Addendum Number: **One (1)**

Title: **Forest Trail Patrol Road Construction**

JEA Solicitation Number: **1410242847-21**

PROJECT / DRAWING NUMBER: 403057-CSTA-S3401
REV: 0
CODE
AREA

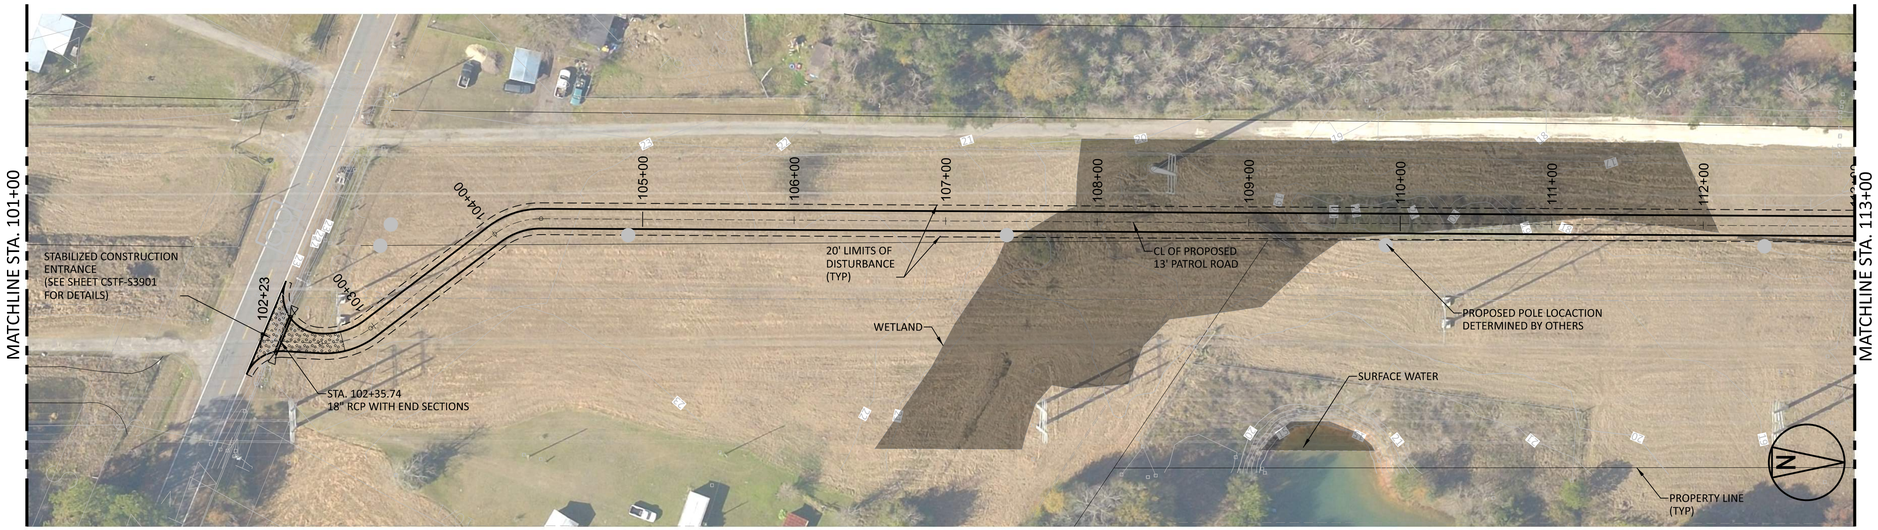
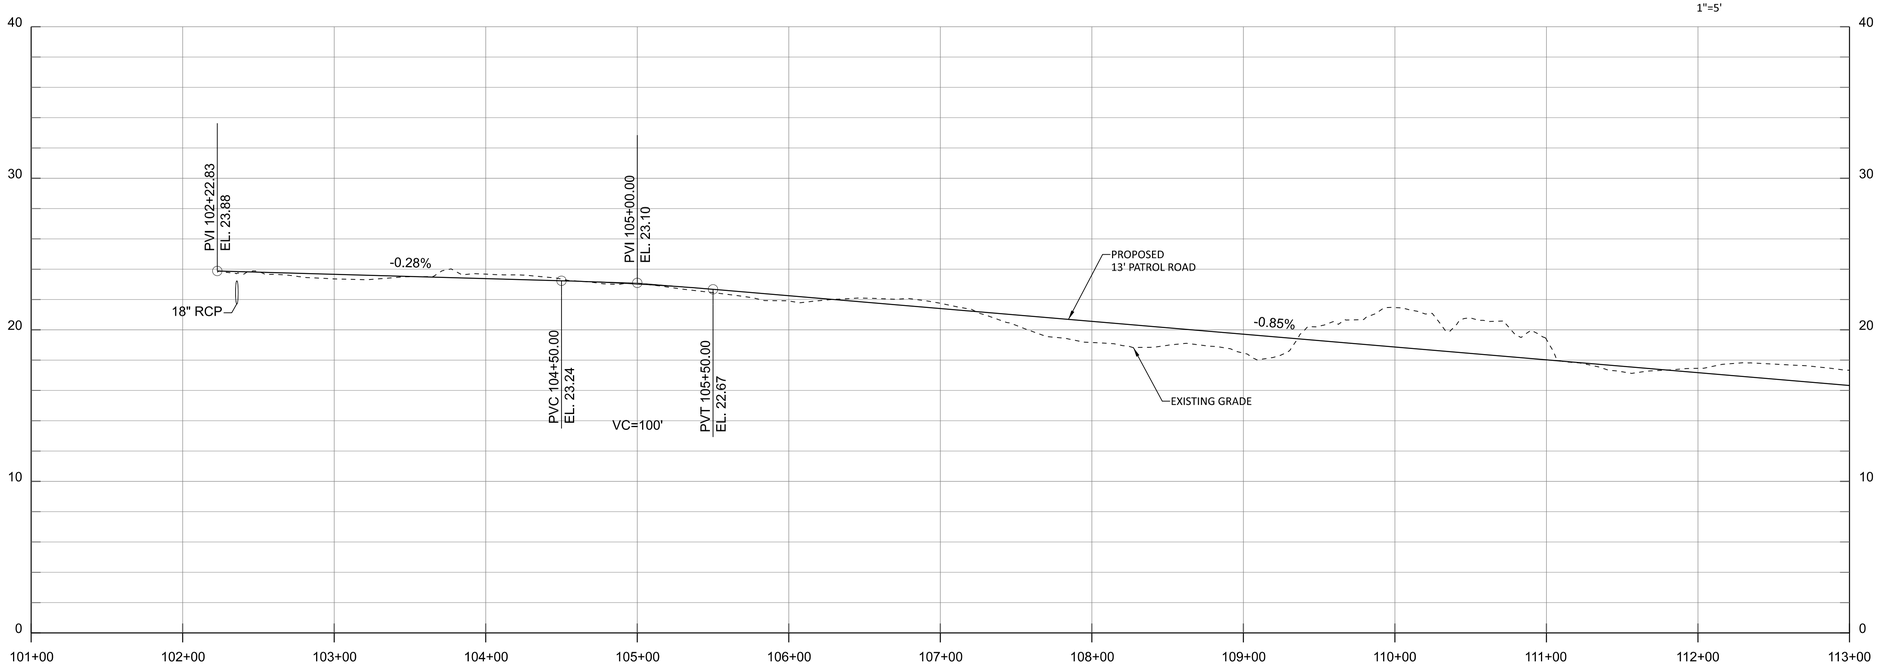
2) **SUPPLIER INQUIRY:** There are several "Wetland" callouts on the drawings for this project; but, the wetlands are not clearly delineated as there were on the Beaver Street and Ginger/Snell Patrol Road project drawings. Is the contractor to assume the entire project is in a wetland?
JEA RESPONSE: Engineer shaded the wetlands for Forest Trail for clearer delineation. PDF attached with changes
